SECTION 00 91 01

**ADDENDUM NO. 1**

This document includes requirements that clarify or supersede portions of the Request for Proposal. This Addendum is a Contract Document.

**BUILDINGS 5 & 6 RENOVATIONS**  
 San Mateo County Community College District

Date: 04/22/11  
 Scale: AS NOTED  
 Project Number: 07013  
 Drawing Number: A2.3R

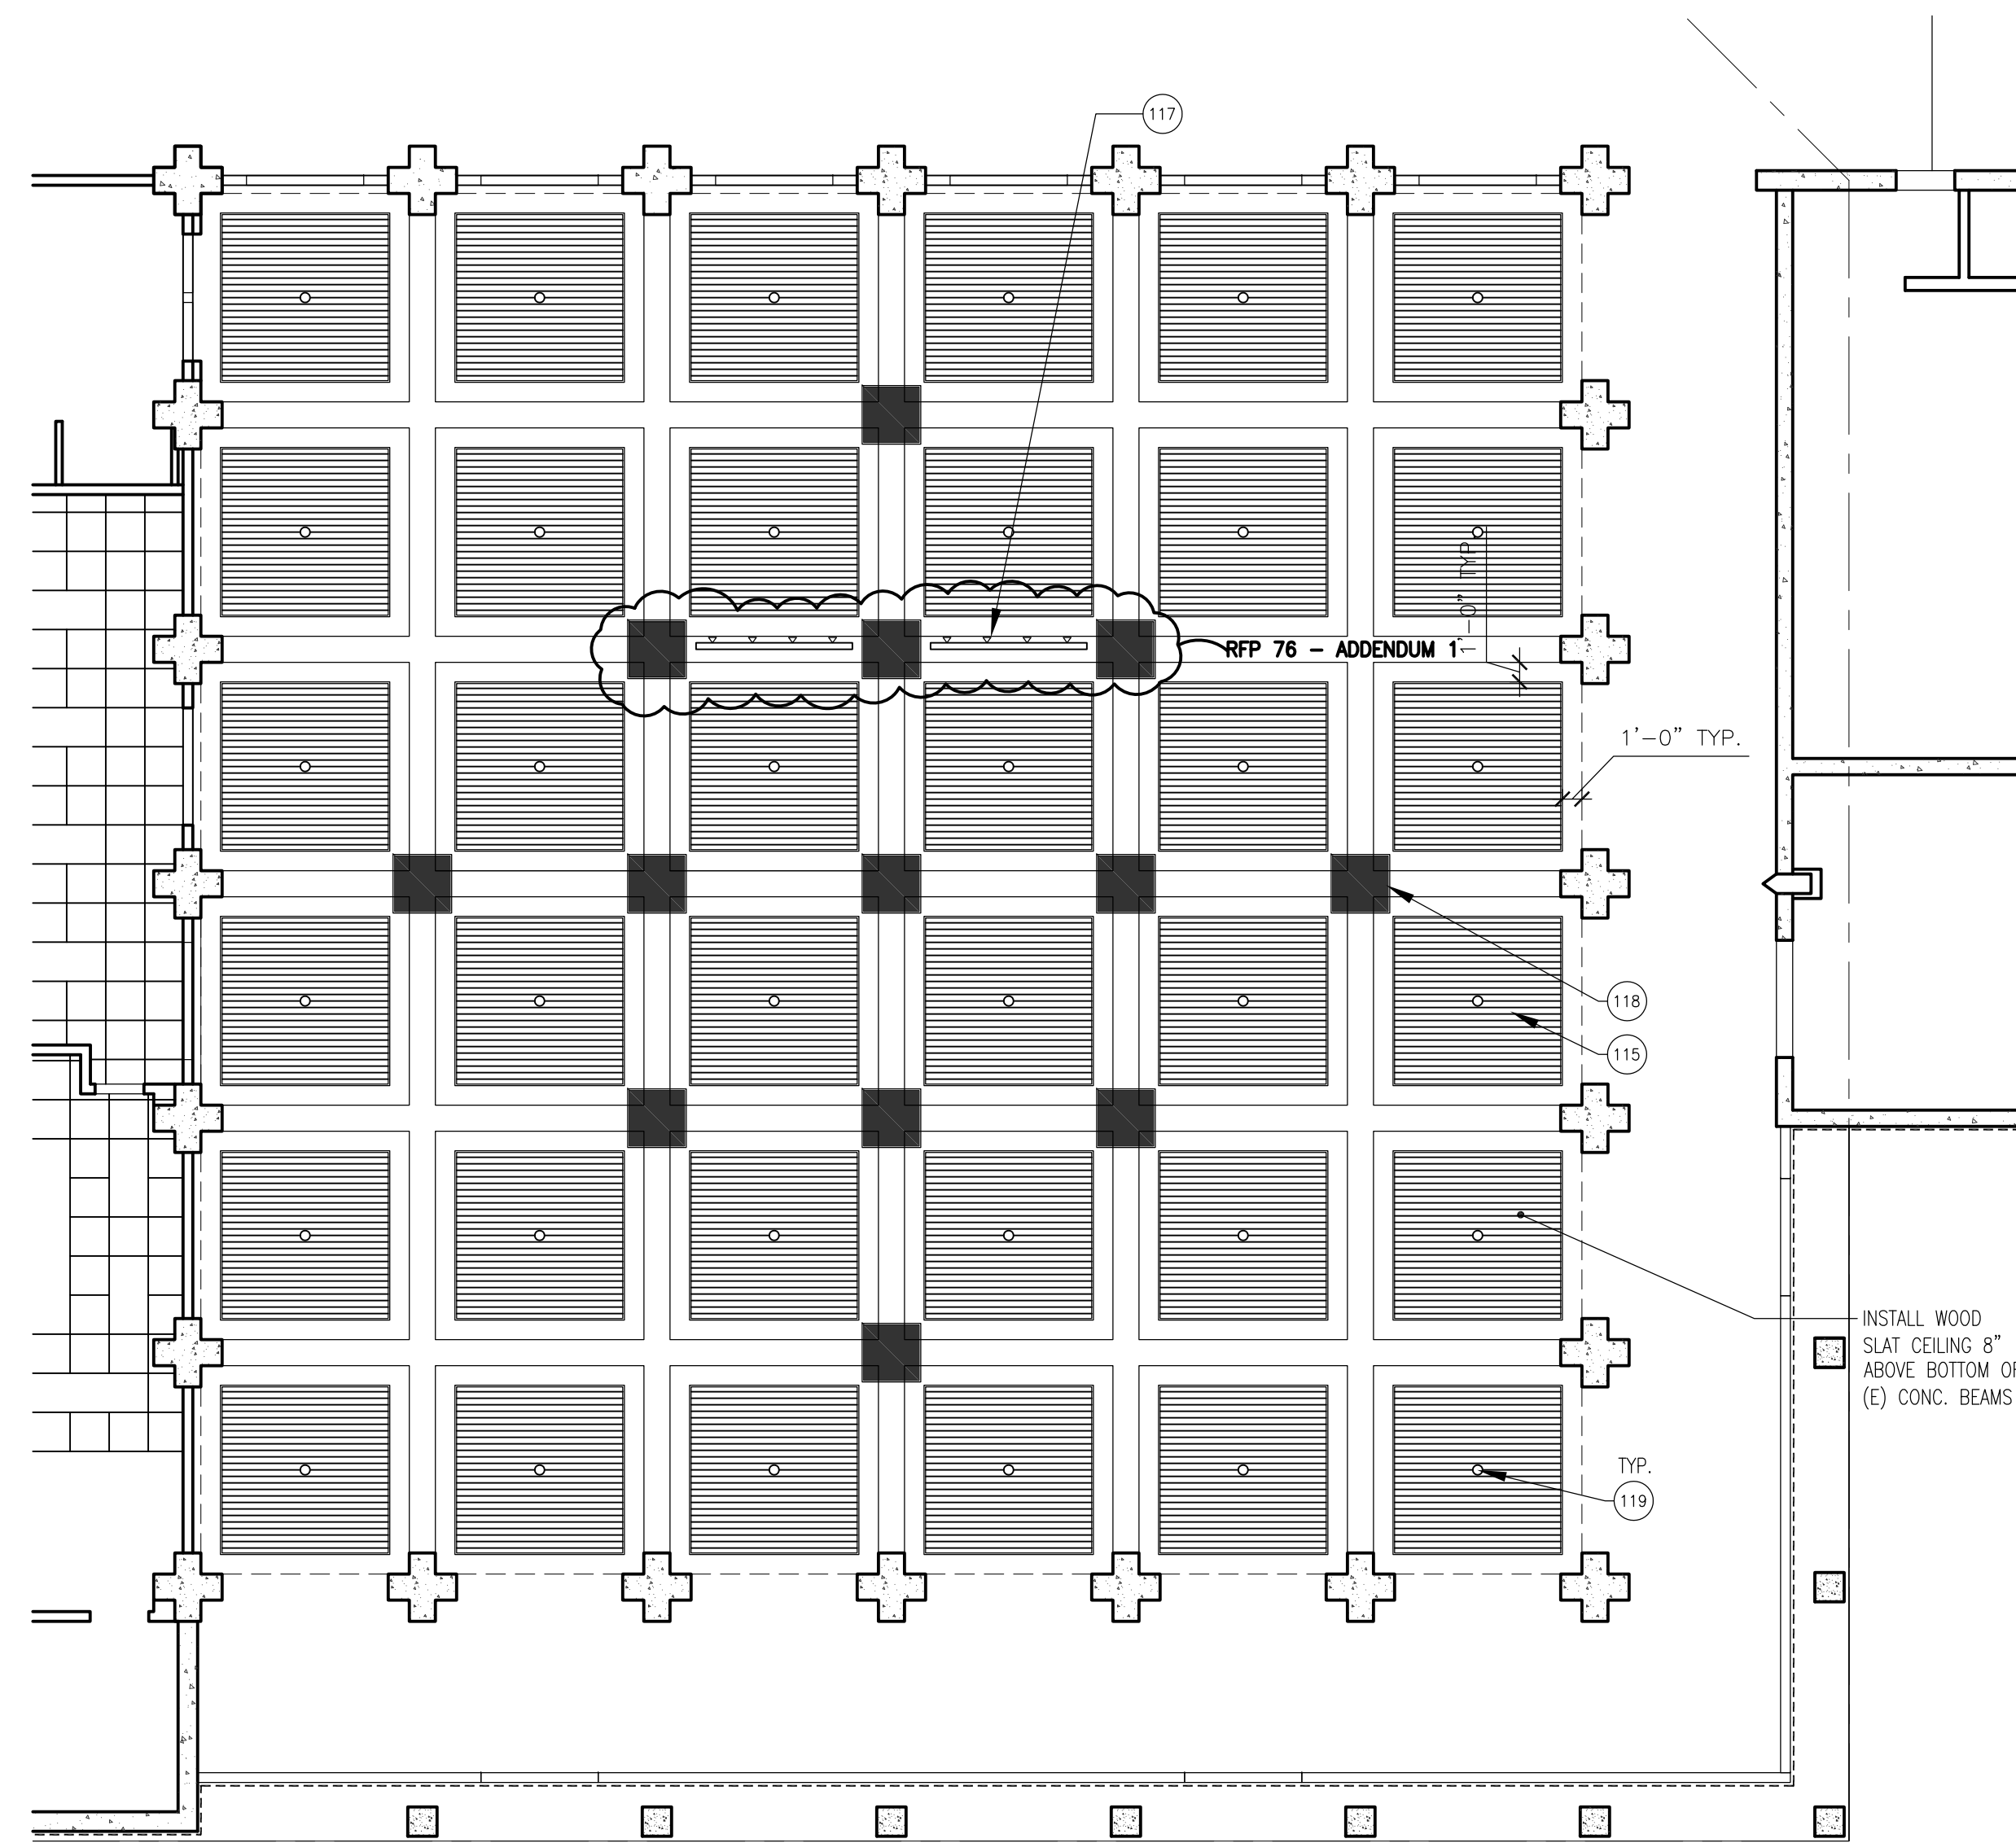
- 2. Removed Add Alternate #10 (Remote Lowering System for Stage Lighting Track) from List of Add Alternates.
- 2. Drawing A2.3R – Third Floor Plan.
  - A. Modified drawing as shown on attached revised Drawing A2.3R:

- 1. Detail 2: Removed stage lighting remote lowering system motors at Mechanical / AV & Lighting Rm 5-321.
    - 2. Detail 2: Revised Partial Floor Plan at Mechanical / AV & Lighting Rm 5-321 to show O.F.C.I. AV Equipment Rack.

Date: 04/22/11  
Scale: AS NOTED  
Project Number: 07013  
Drawing Number: A3.34R

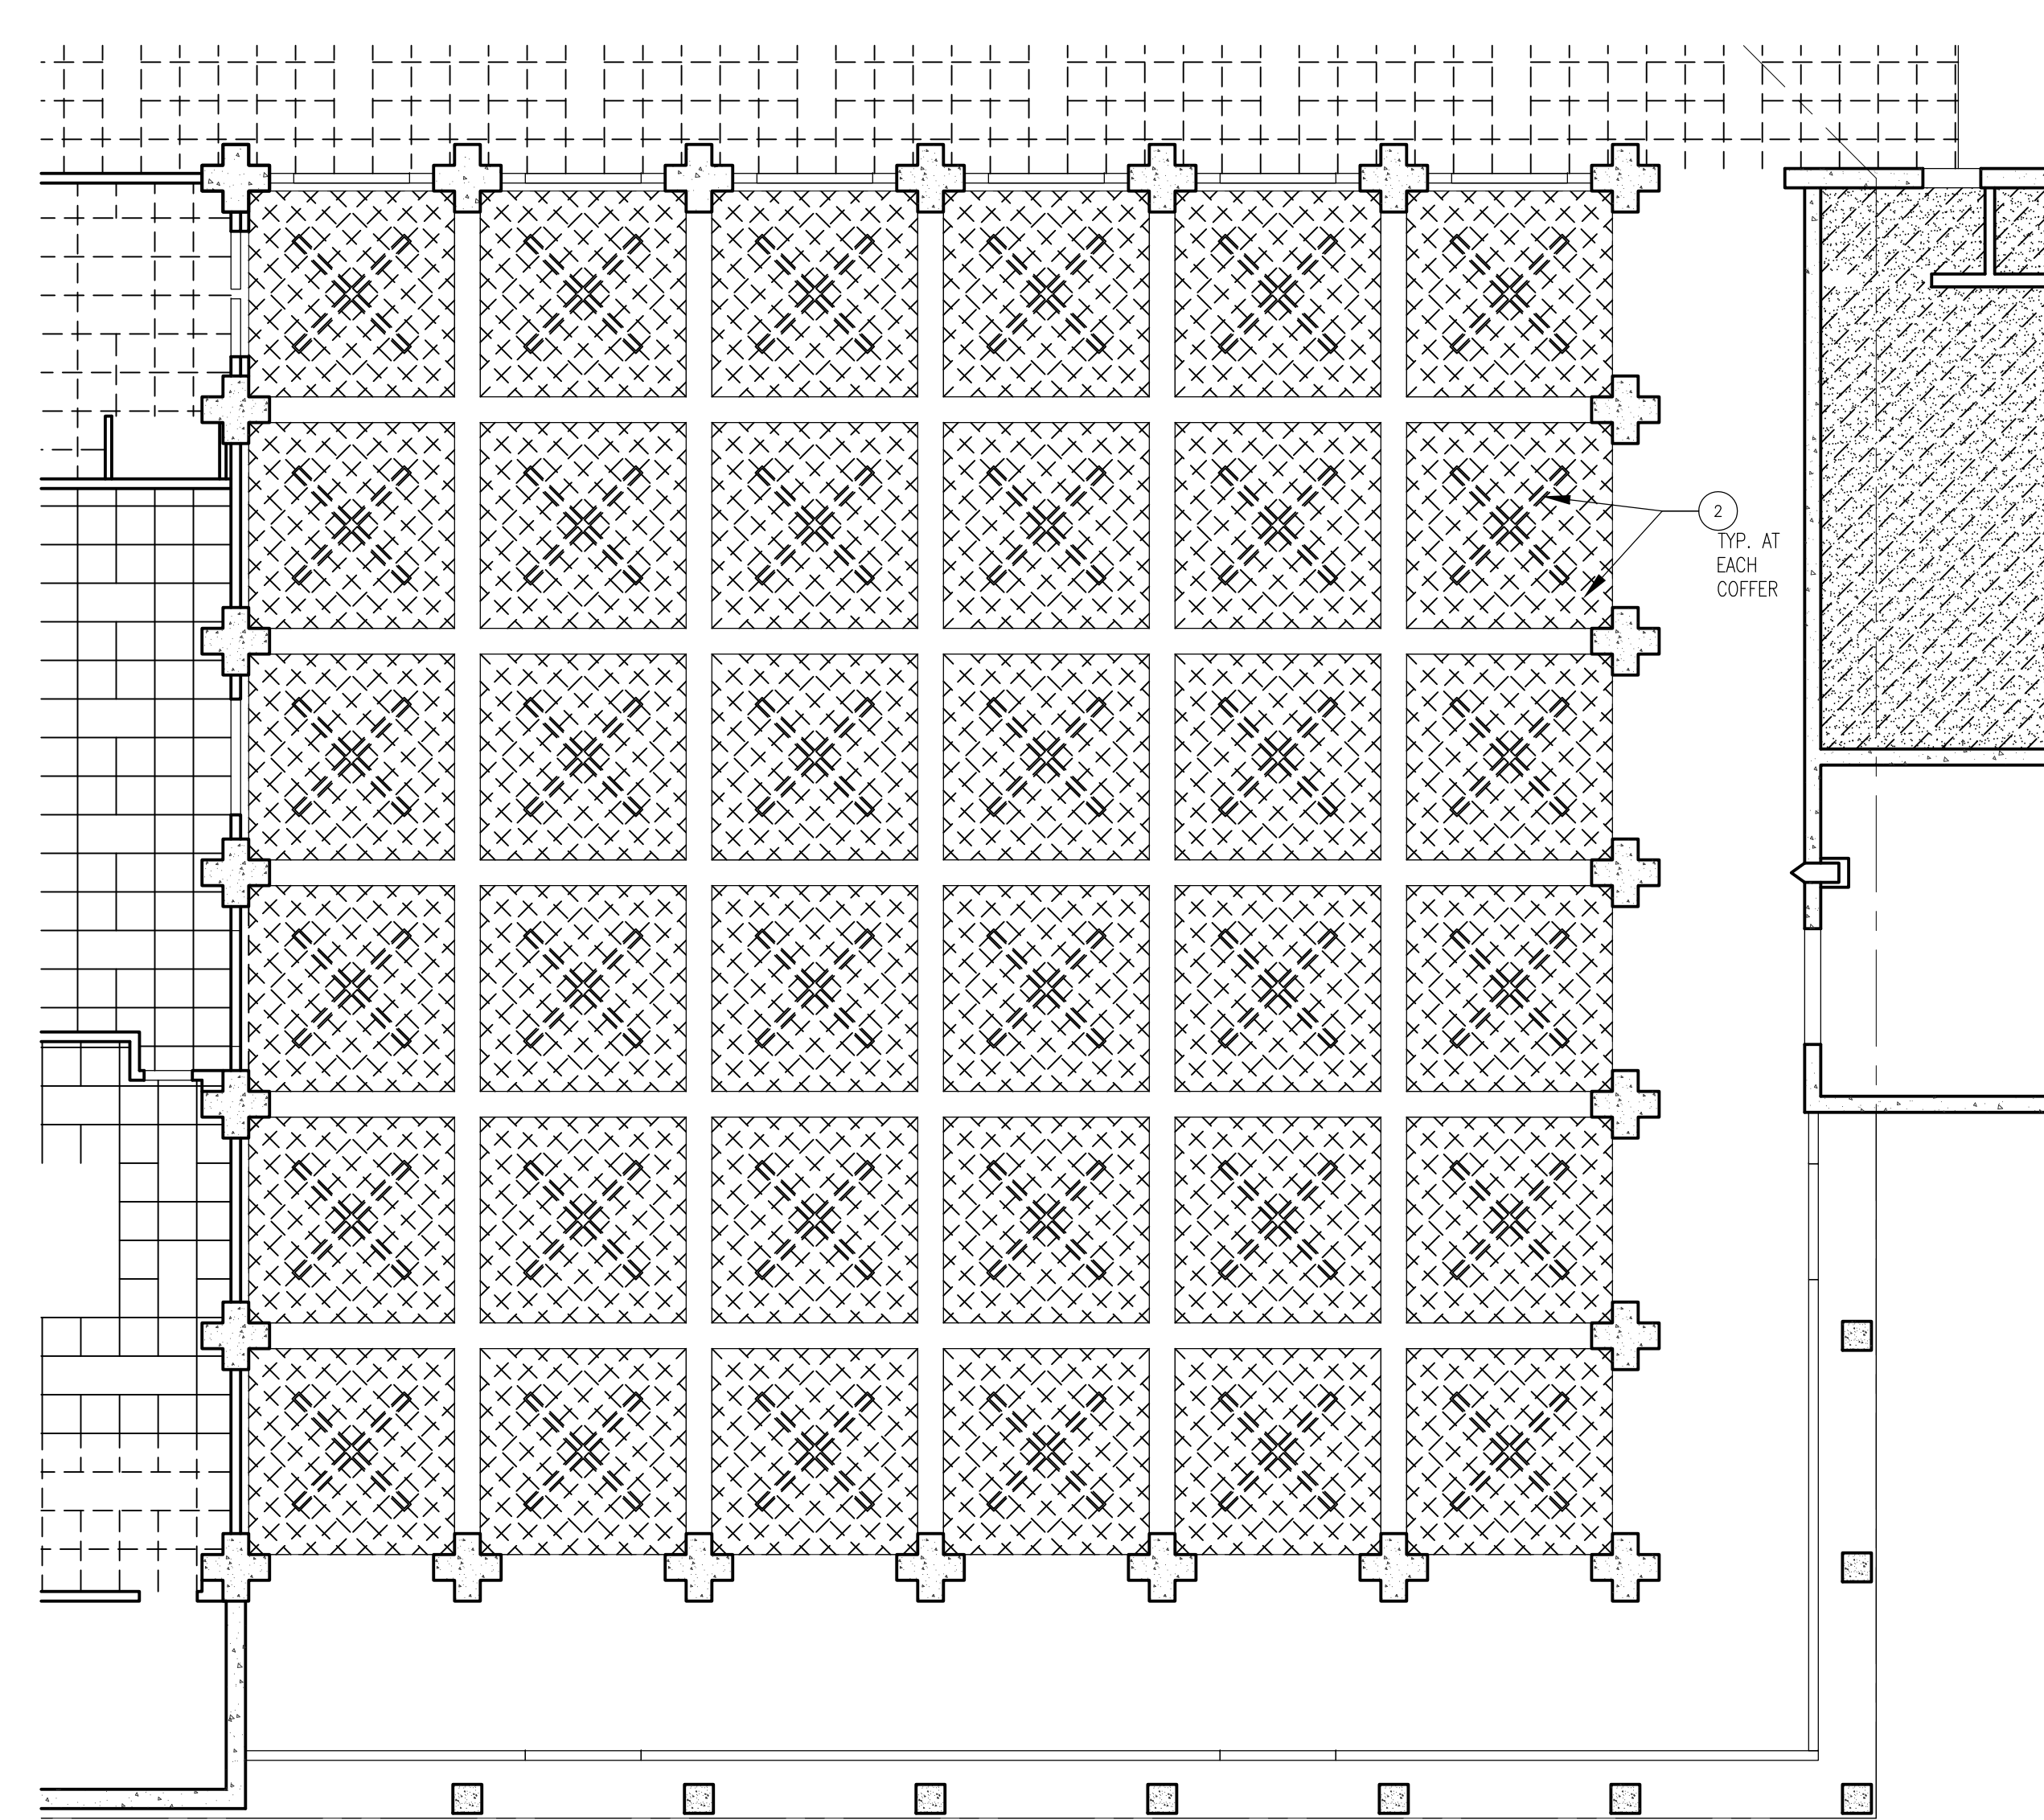
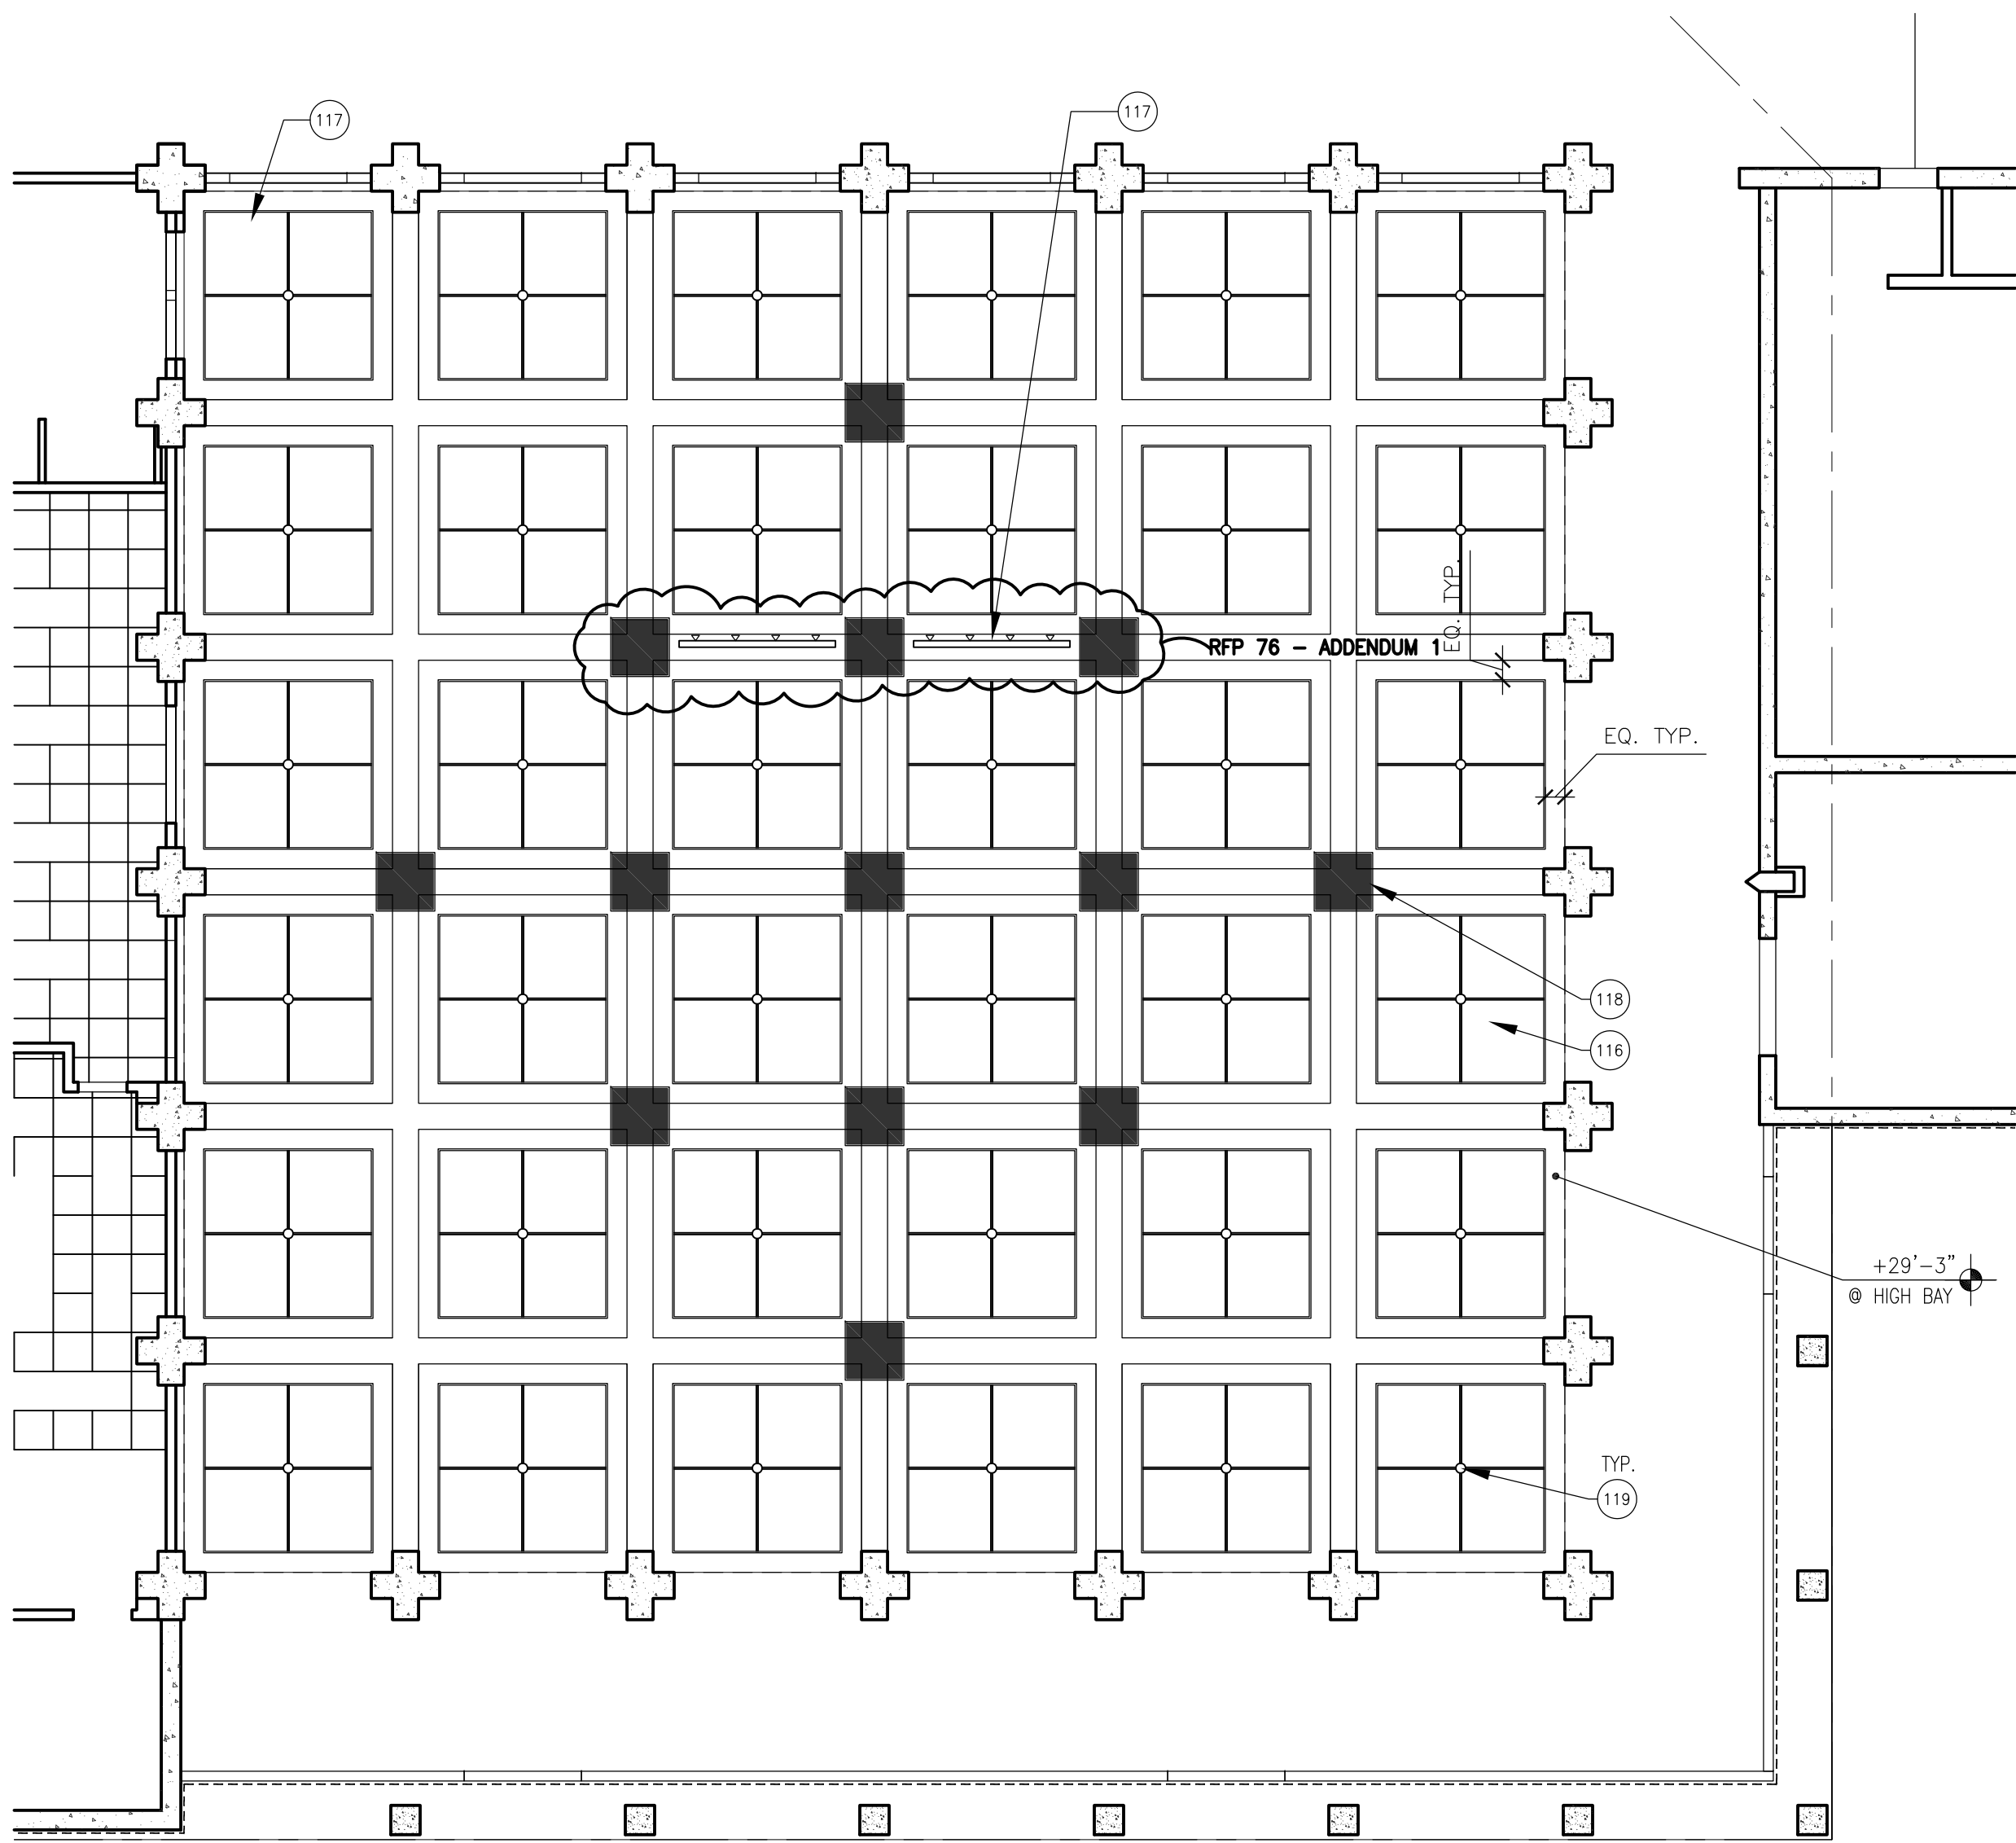
- 3. Drawing A3.34R – Third Floor Upper Reflected Ceiling Plan – Add Alternates.
  - A. Modified drawing as shown on attached revised Drawing A3.34R:
    - 1. Removed Add Alternate #10 from list of Add Alternates.

- 2. Replaced Stage Lighting Remote Lowering System with Fixed Stage Track Lighting for Detail 2, 3 and 4.
    - 3. Added Sheet Note 117 for Stage Lighting at bottom (e) coffered ceiling beam.
